## Addenda No. 4

**SUBJECT:** I-5: Tualatin River – Willamette River Bridge Sec.  
Pacific Highway  
Multnomah, Washington & Clackamas Counties County  
Grading, Drainage, Structures, Paving, Signing & Signals Project  
(Bids to be opened and read April 23, 2009)

### The following changes are made to the Project Special Provisions:

SHEET NO.  
 2A-8

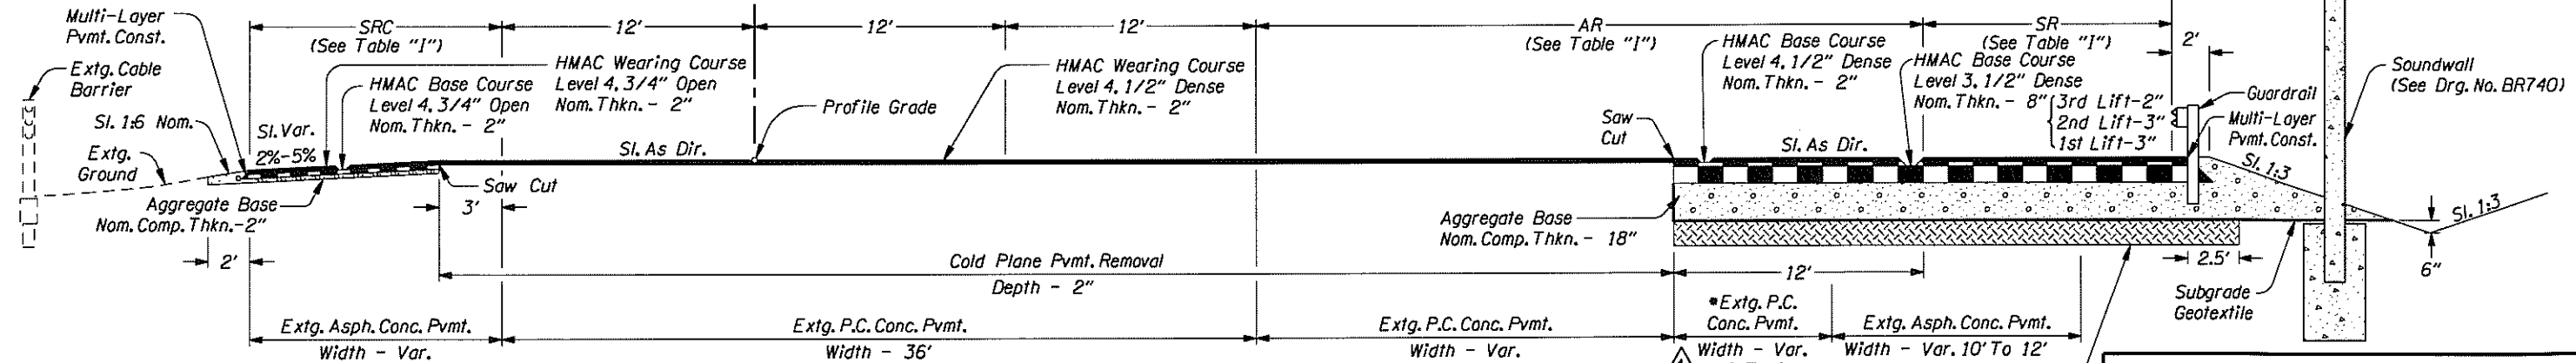
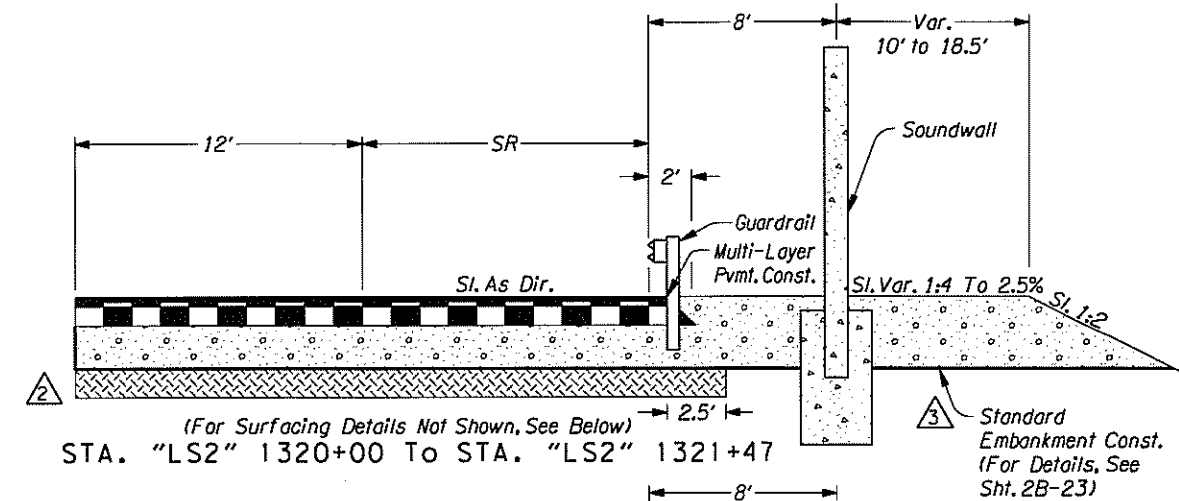
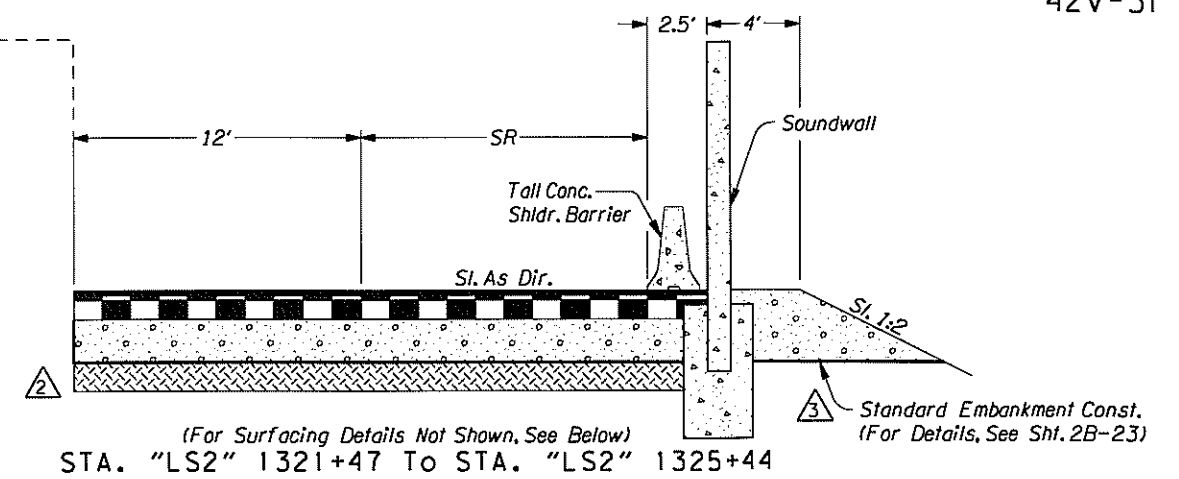
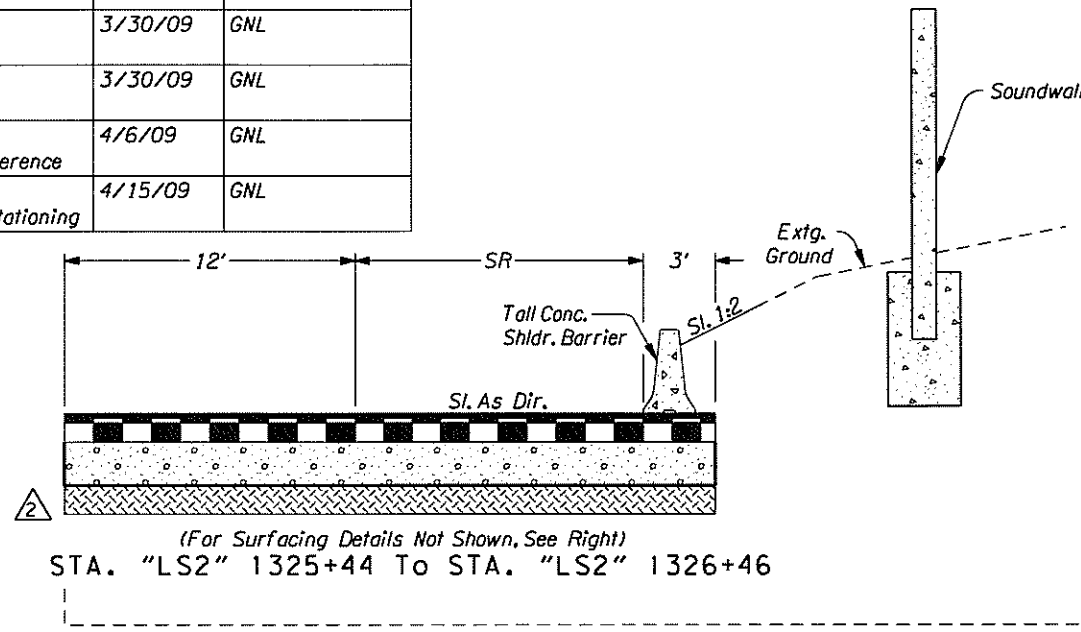
Rev. No.	Description	Date	Engineer
1	Addenda #1 - Added Saw Cut Note	3/30/09	GNL
2	Addenda #1 - Added Cement Treated Subgrade	3/30/09	GNL
3	Addenda #2 - Adjusted Agg. Base & Added Detail Reference	4/6/09	GNL
4	Addenda #4 - Adjusted Extg. Pgmt. Dimensions And Stationing	4/15/09	GNL

SHEET NO. **2B**

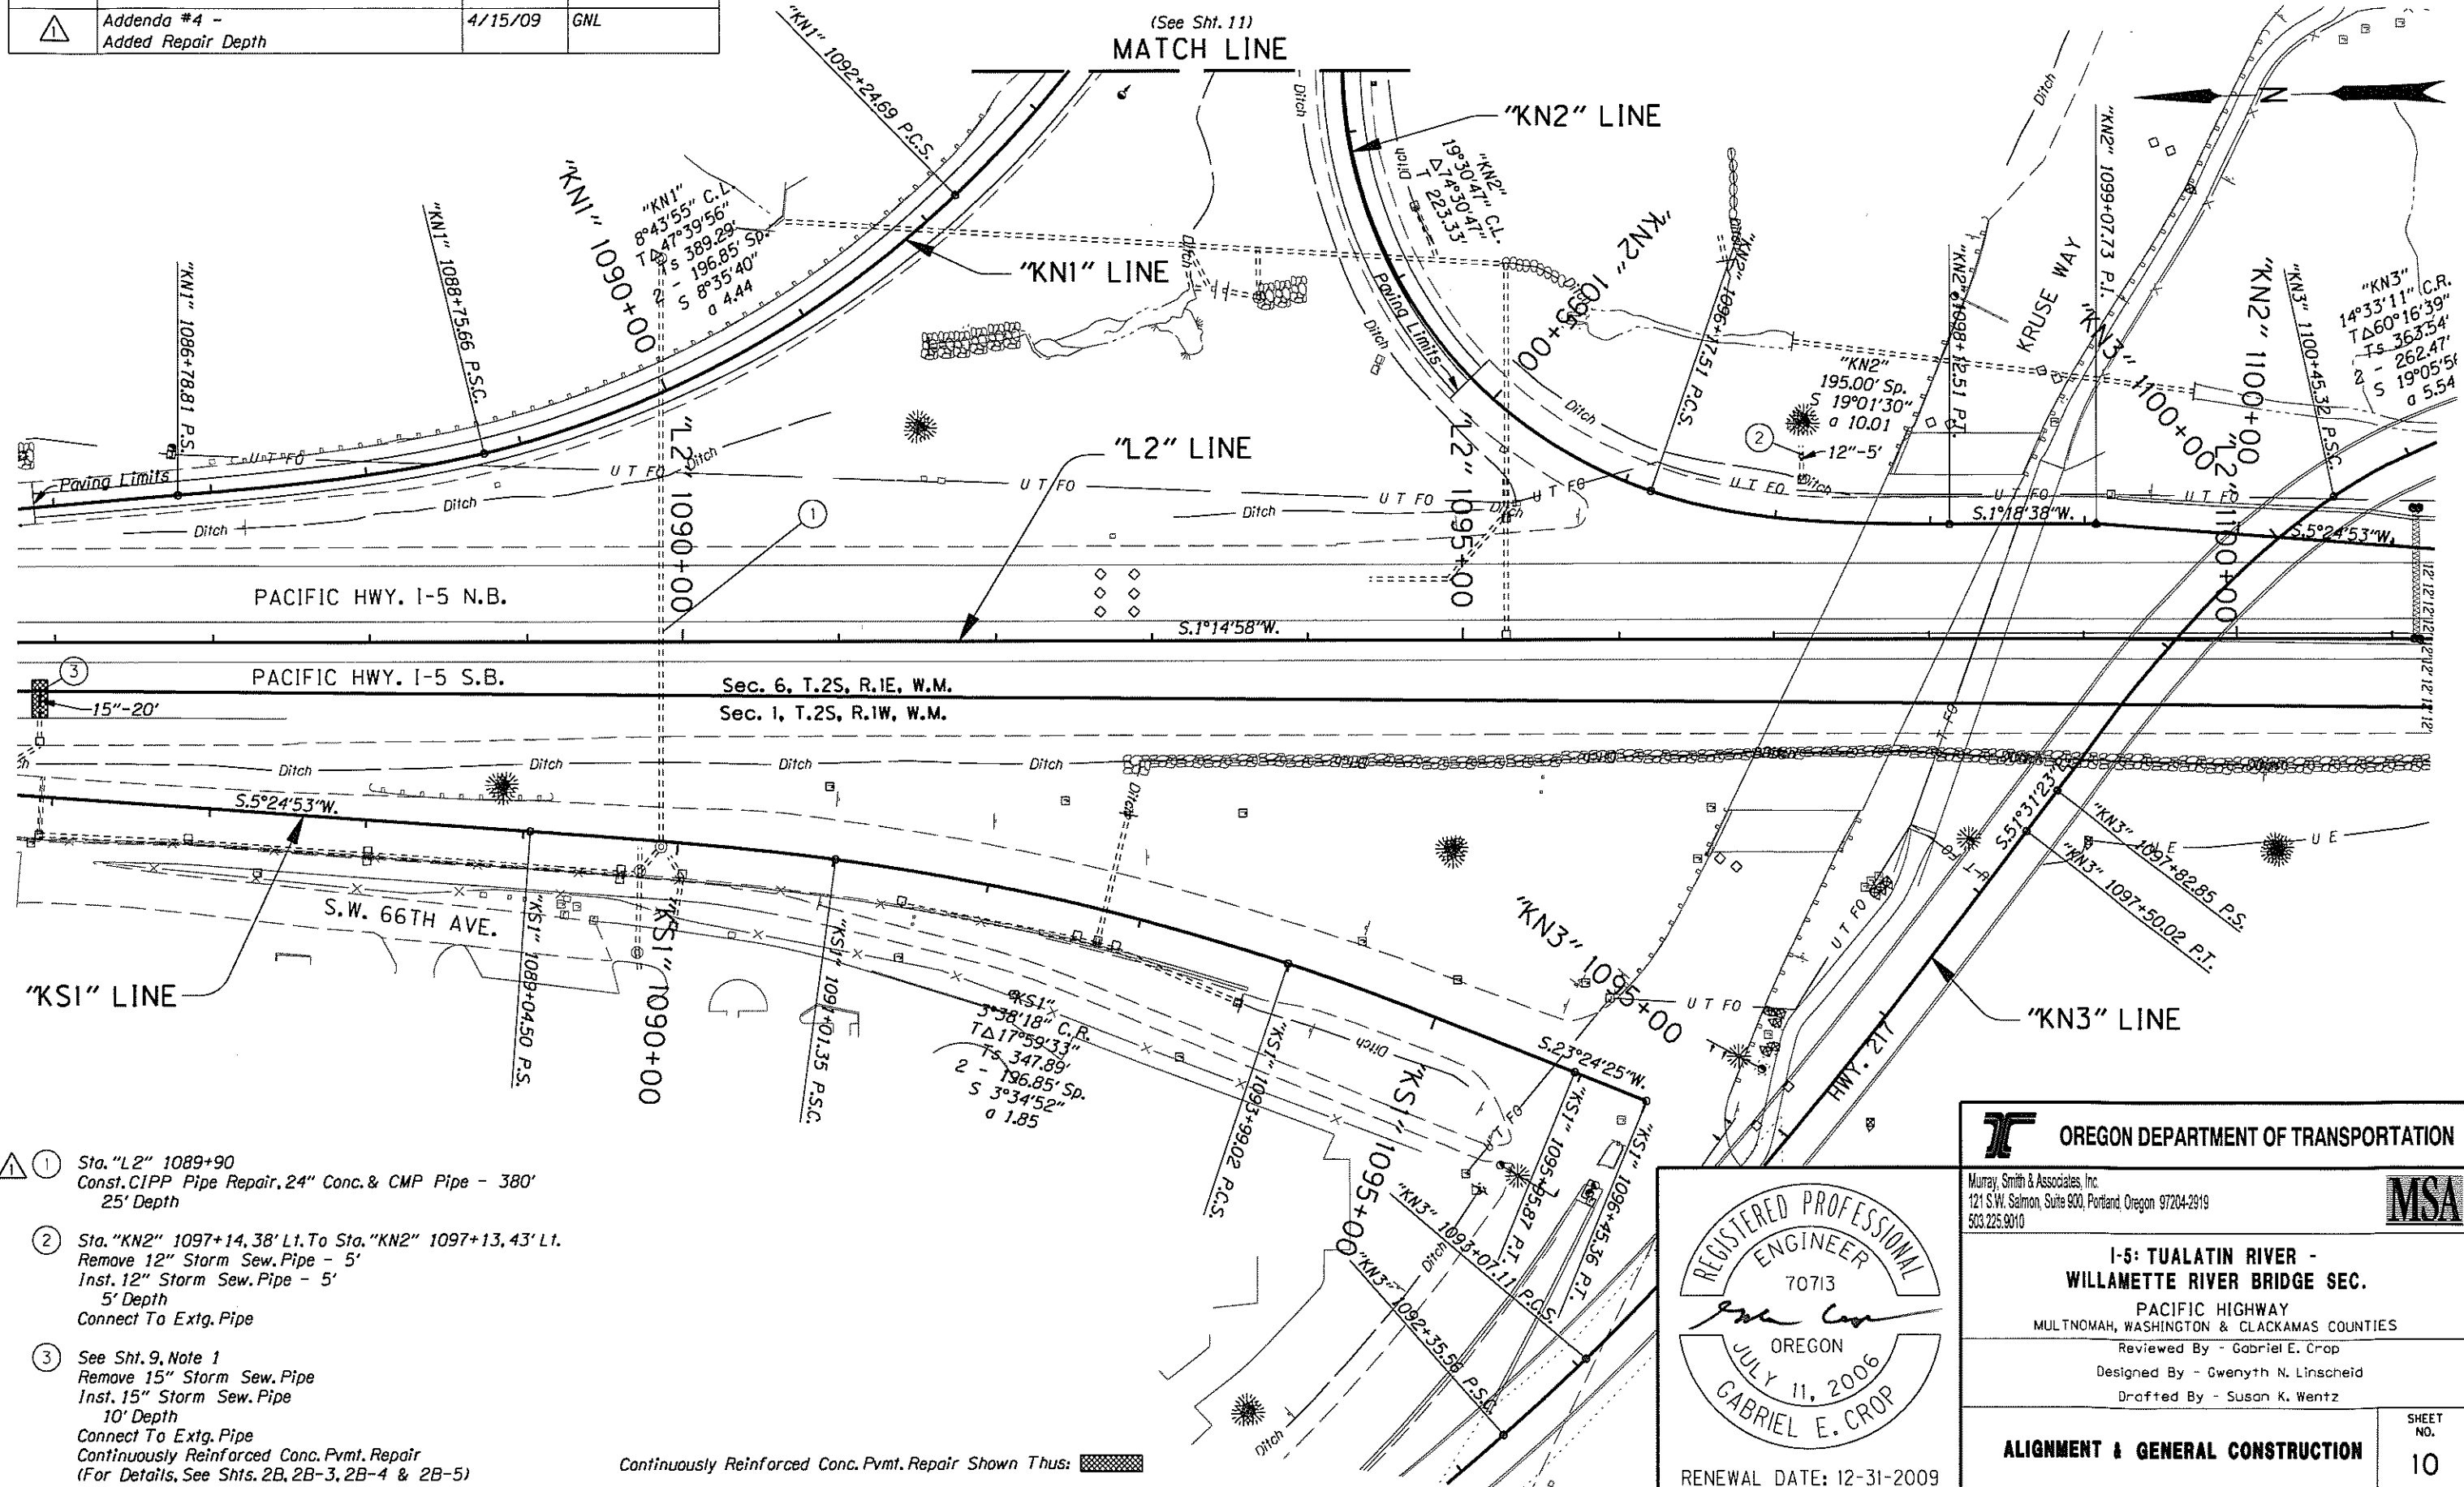
Rev. No.	Description	Date	Engineer
△	Addenda #4 - Changed Pvmt. Repair Width	4/15/09	GNL

SHEET NO. 10

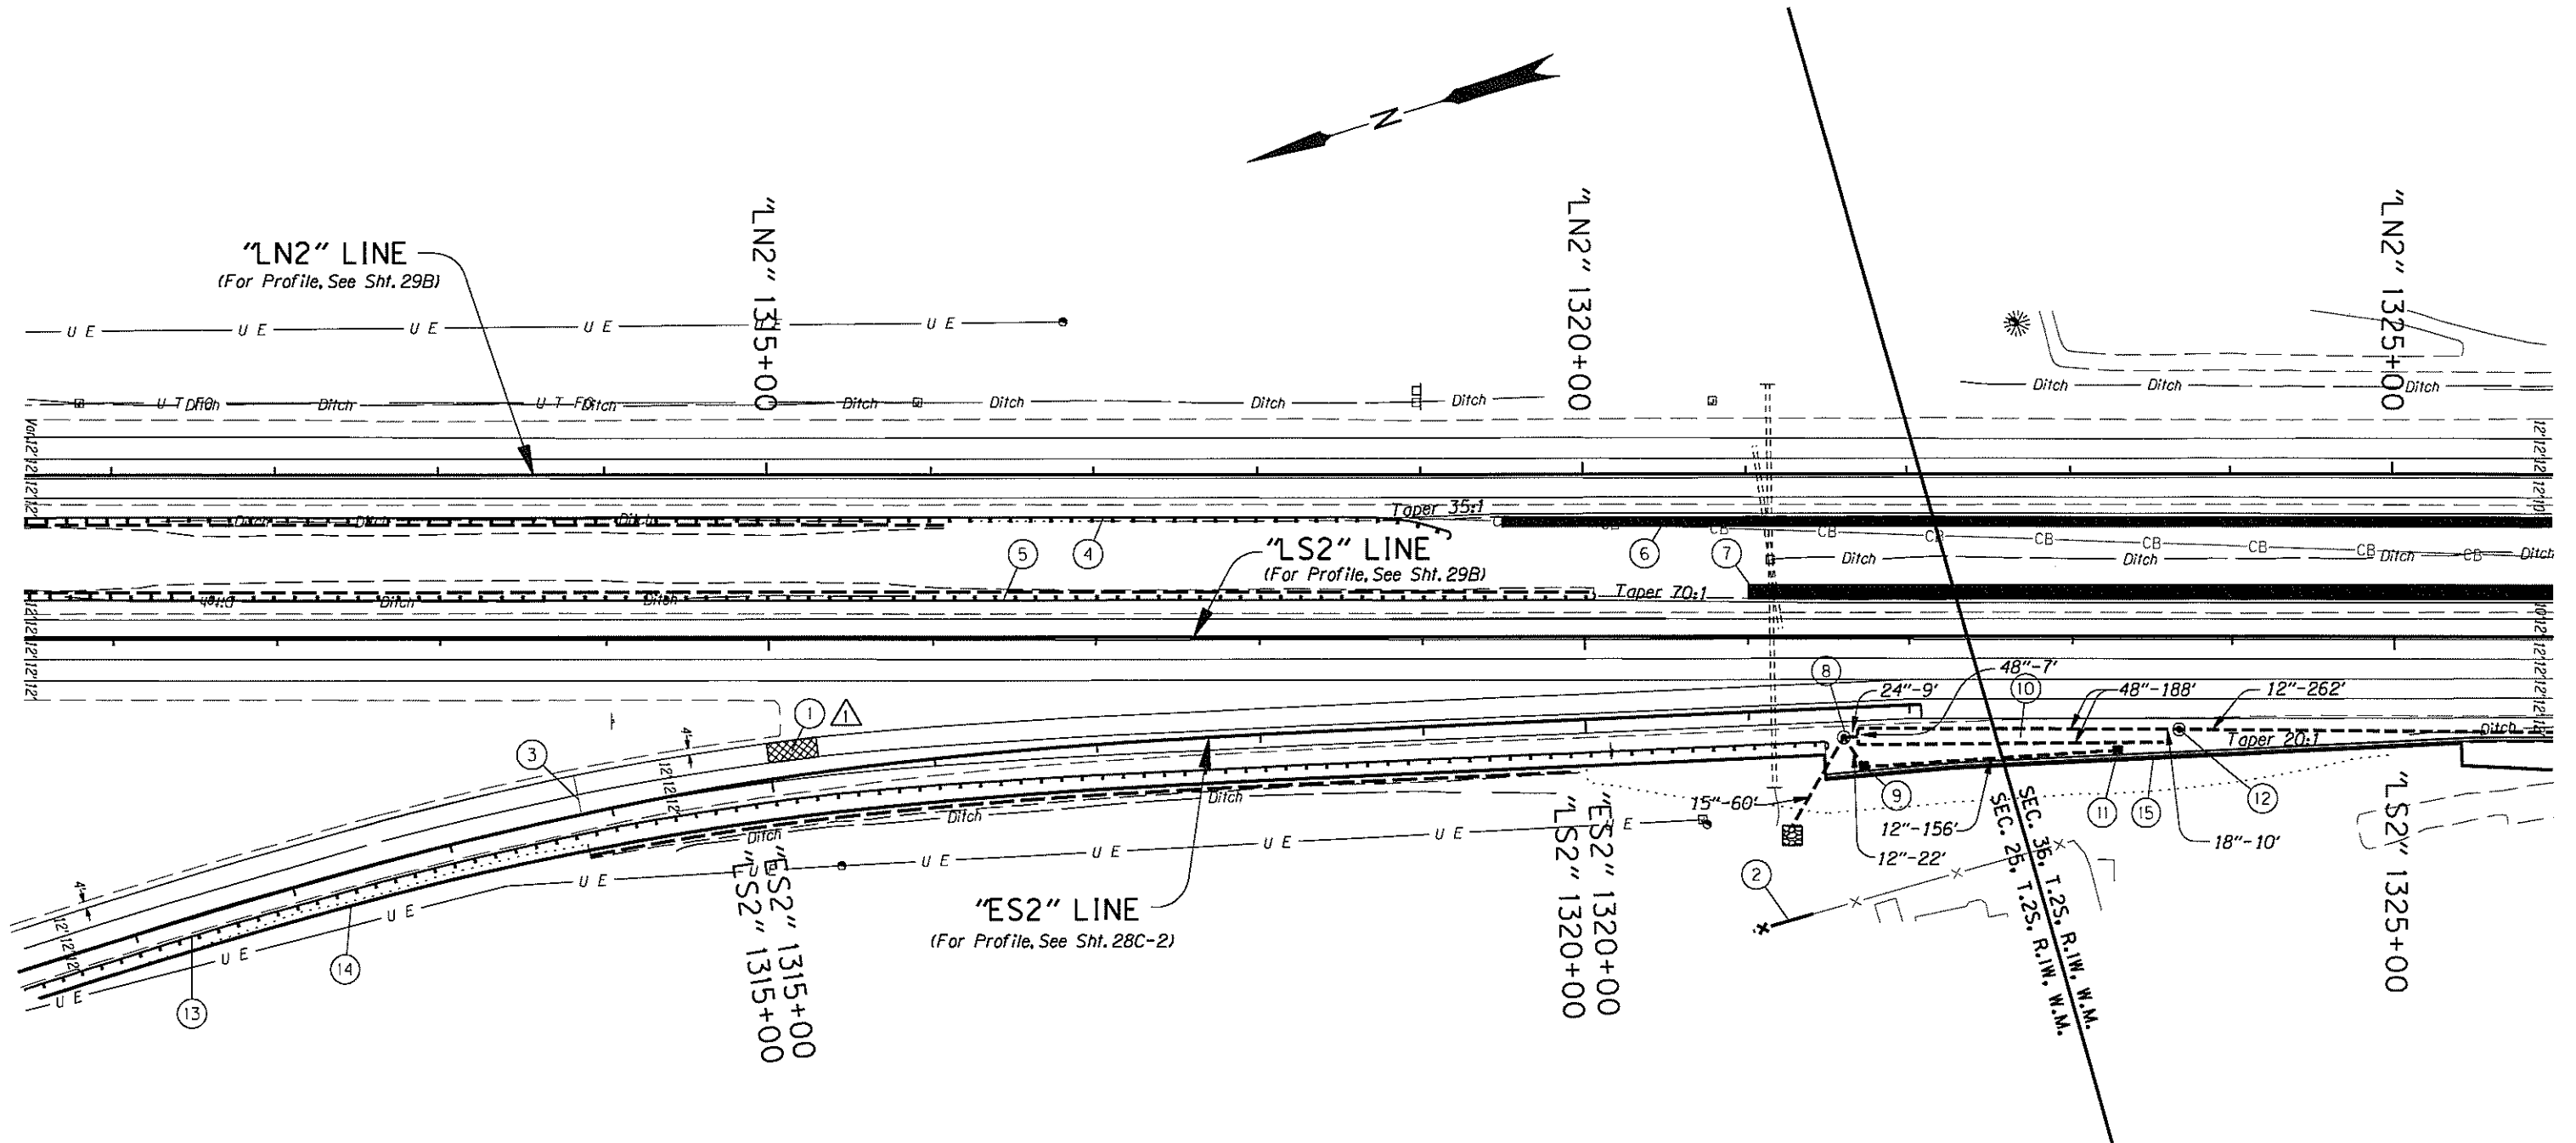
Rev. No.	Description	Date	Engineer
1	Addenda #4 - Added Repair Depth	4/15/09	GNL
